TECHNICAL SERVICE BULLETIN

TSB#: 16-002

Correct wiring to the generator start switch in command center.

| 2016 Designer Fifth Wheel | 37RS | G1S1 | 0053-55 |

FIG 1

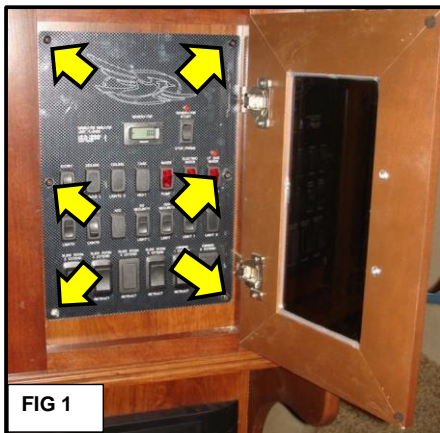
1 Fig 1: Remove 6 screws on the Command Center panel.

FIG 2

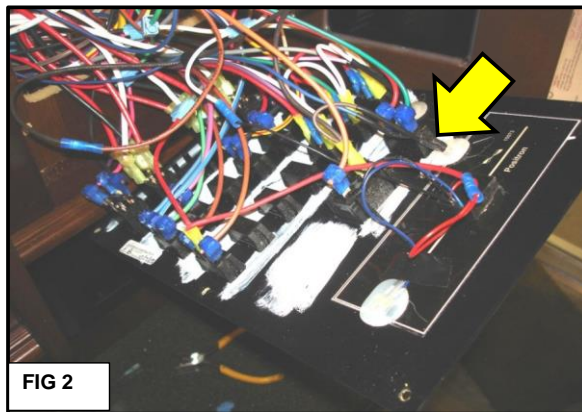
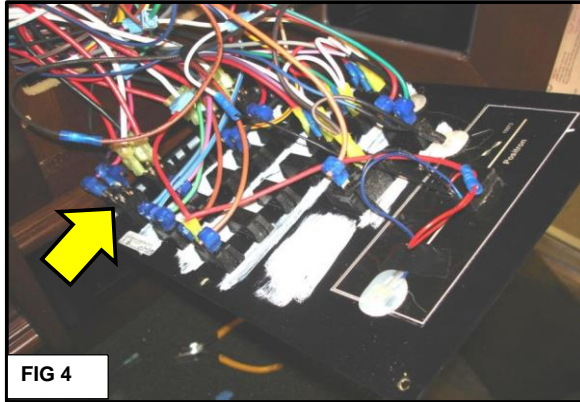
Fig 2: Pull the panel out and look at the backside. Locate the **GENERATOR START** switch with double brown wires.

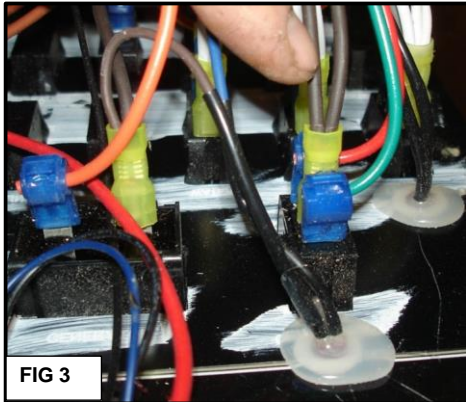
- 2 **Fig 3:** **GENERATOR START** switch shown with double brown wires.
 Pull the connector with the brown wires off the switch and wrap it with electrical tape so it won't short out to anything.
Fig 4: Locate the **SLIDE 2 EXTEND** switch on the opposite end of the panel in opposite corner.

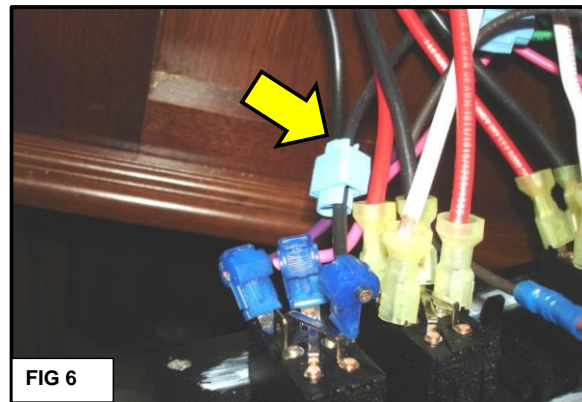
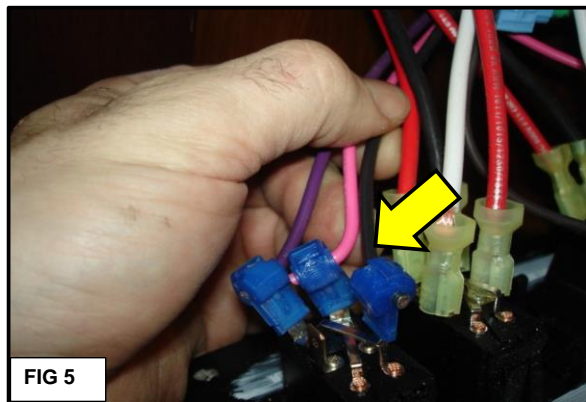
- 3 **Fig 5:** The **SLIDE 2 EXTEND** switch will have a black, pink and purple wire attached to it as shown.
Fig 6: Put the Scotchlok connector on the black wire of the **SLIDE 2 EXTEND** as shown. (this is the B+ wire powering the switch)
 Insert the plain end of the new 14ga black jumper wire into the Scotchlok connector, and crimp the connector with pliers.

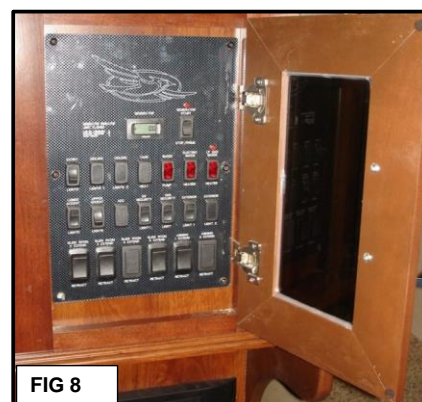
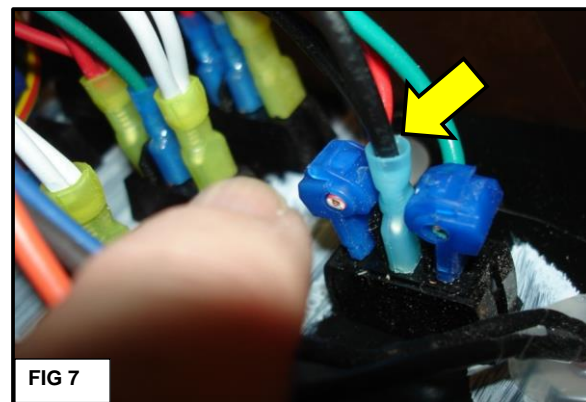
- 4 **Fig 7:** Attach the other end of the new 14ga black jumper wire to the **GENERATOR START** switch center terminal.
Fig 8: Re-attach the Command Center panel with the 6 screws removed previously.
 5 Test the generator (or the generator prep start/stop relay pack) for start and stop functionality.
